Remarks/Arguments

ANNOTATED MARKED UP DRAWING

Fig.8

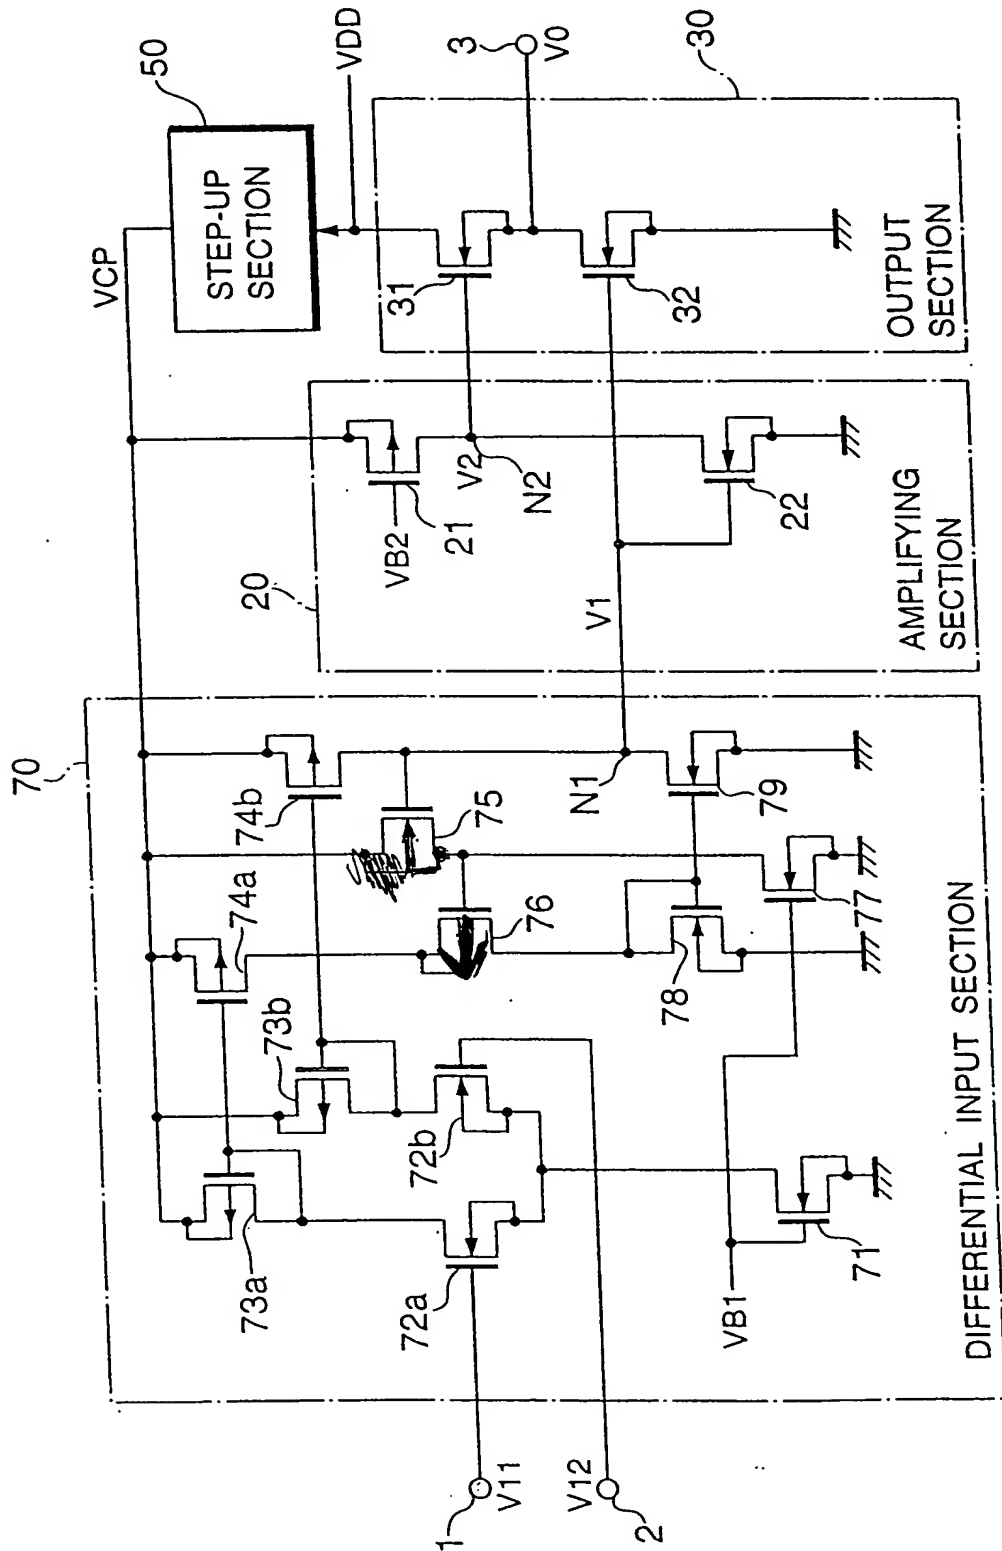
With regard to the drawings, Fig. 8 has been corrected as indicated in the red-linked Annotated Marked-up Drawings enclosed herewith, wherein MOS transistor 76 has been illustrated correctly as p-channel as supported on page 16, lines 1-3 of the application, and the depiction of n-channel MOS transistor 75 has been corrected. Also, Fig. 9 has been corrected wherein MOS transistor 85 has been illustrated correctly as p-channel as supported on page 18, lines 5-6 of the application, and the depiction of n-channel MOS transistor 86 has been corrected.
